**Invitation to Bid  
Kenai Municipal Airport  
2021 Kenai Municipal Airport Improved Airfield Drainage**

**Addendum No. 1  
August 11, 2021**

2021 IMPROVED AIRFIELD DRAINAGE

SHEET TITLE  
STORM DRAIN  
PLAN AND PROFILE

SHEET  
C1.01

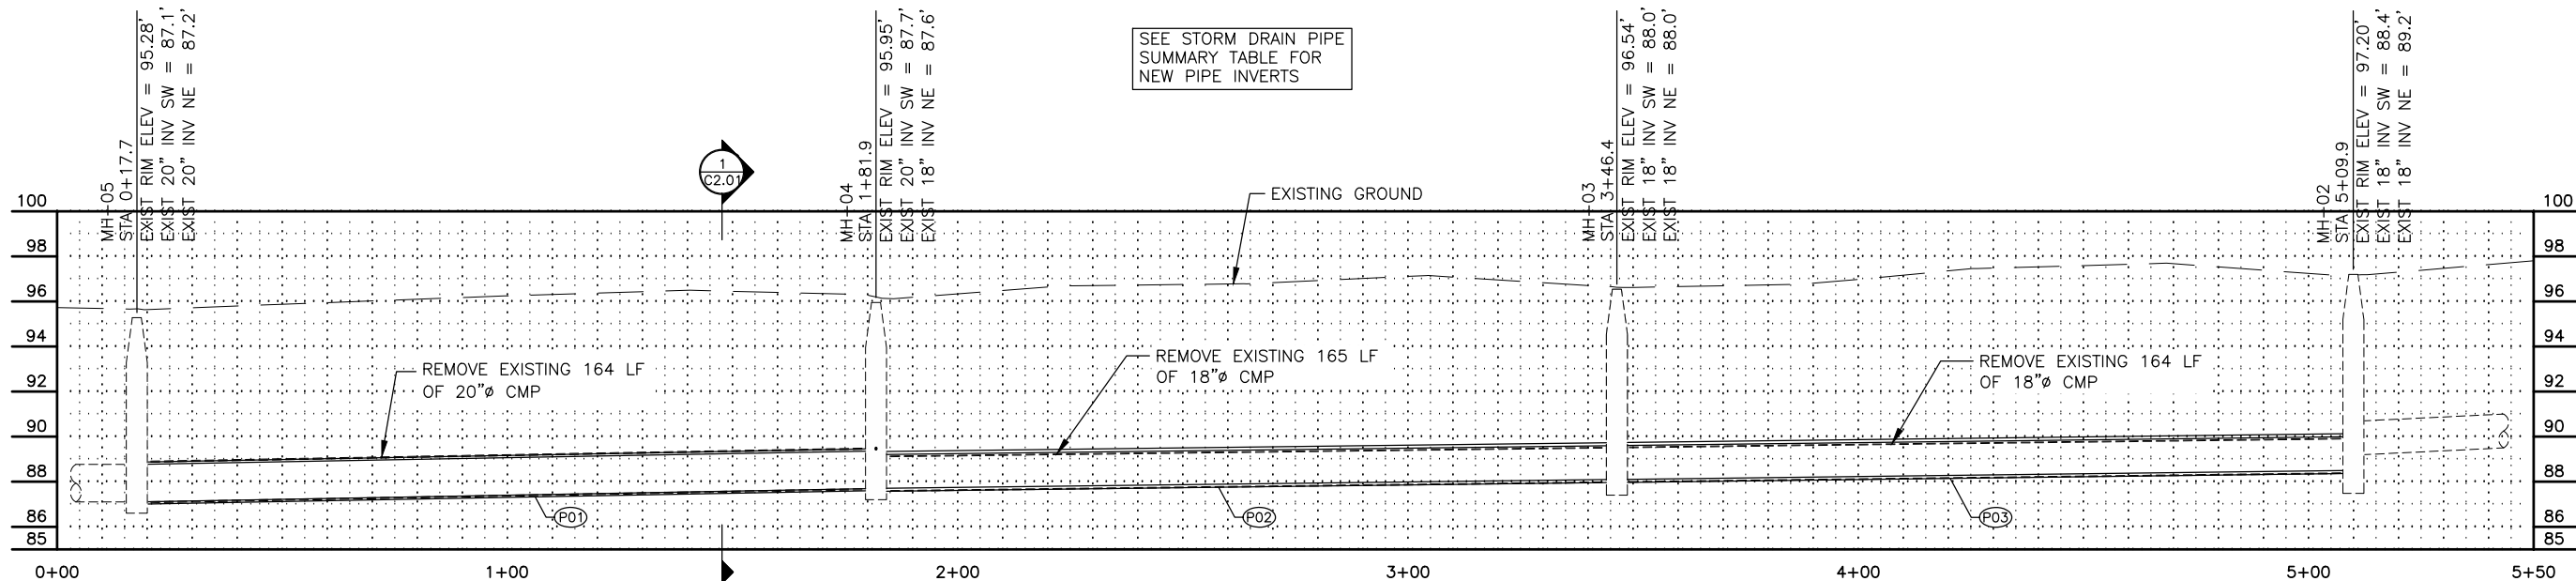
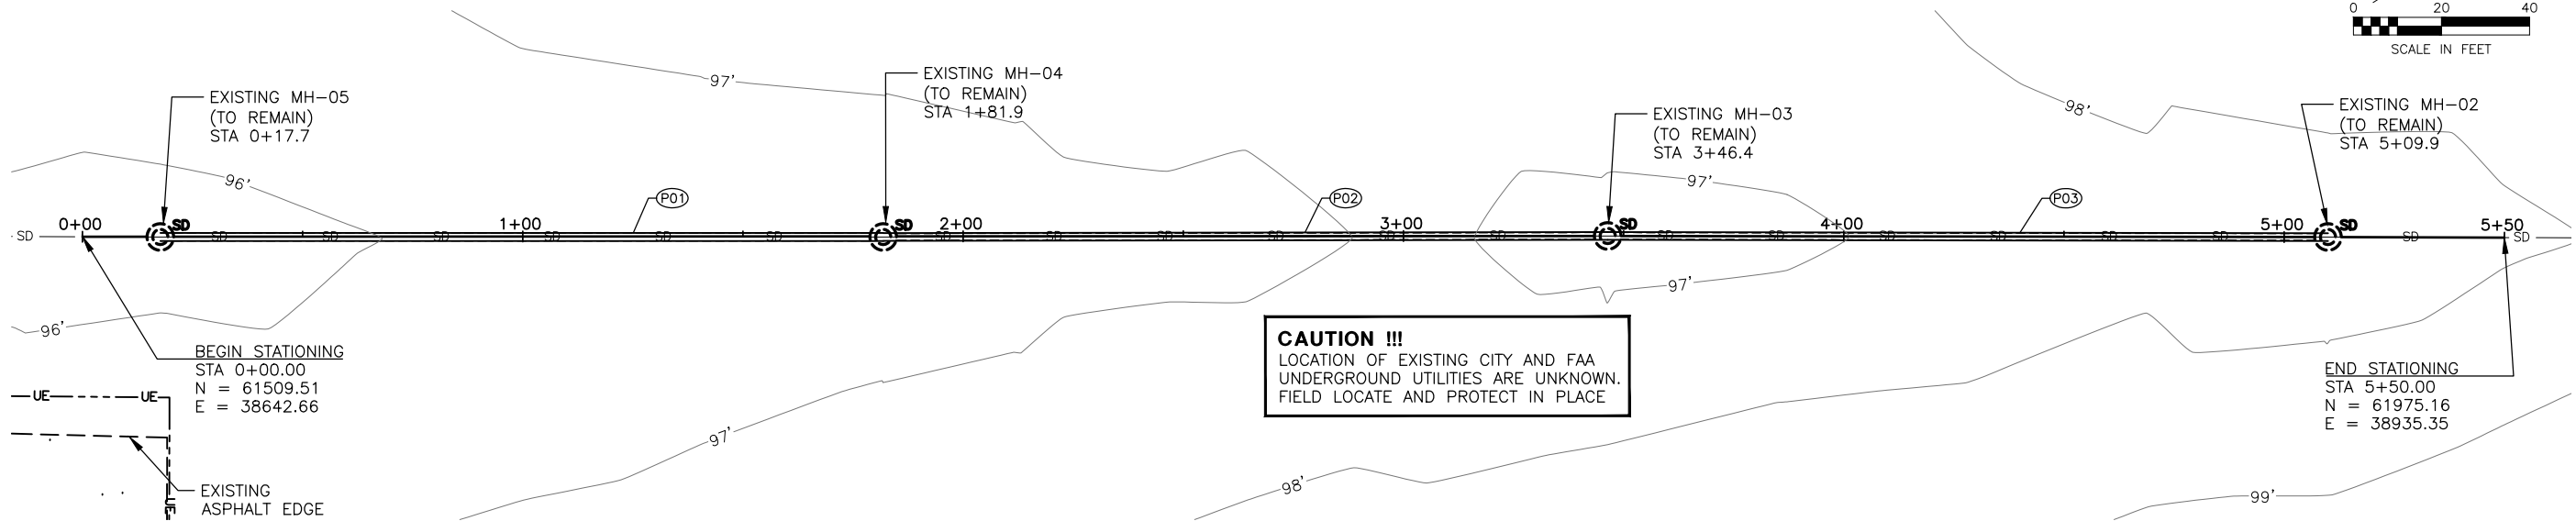
1. **REPLACE** Sheet C1.01 with the attached drawing sheet C1.01 revised on August 3, 2021, which modified the pipe size of Pipe Number P01 in the Storm Drain Pipe Summary table.

13. Question: Pay item A-3 is calling for 20" CPEP, this size is not made in CPEP. The next size up is 24". Please advise what we are to bid to the contractors.

Response: See revised Bid Schedule, modification to Section D-701 PIPE FOR STORM DRAINS AND CULVERTS 701-5.1, and revision to Sheet C1.01 per this ADDENDUM 1.

STORM DRAIN PIPE SUMMARY						
PIPE No.	SIZE (IN)	LENGTH (FT)	INLET		OUTLET	SLOPE %
			LOCATION	INVERT	LOCATION	
P01	18	164	MH-04	87.7	MH-05	87.1
P02	18	165	MH-03	88.1	MH-04	87.7
P03	18	164	MH-02	88.5	MH-03	88.1
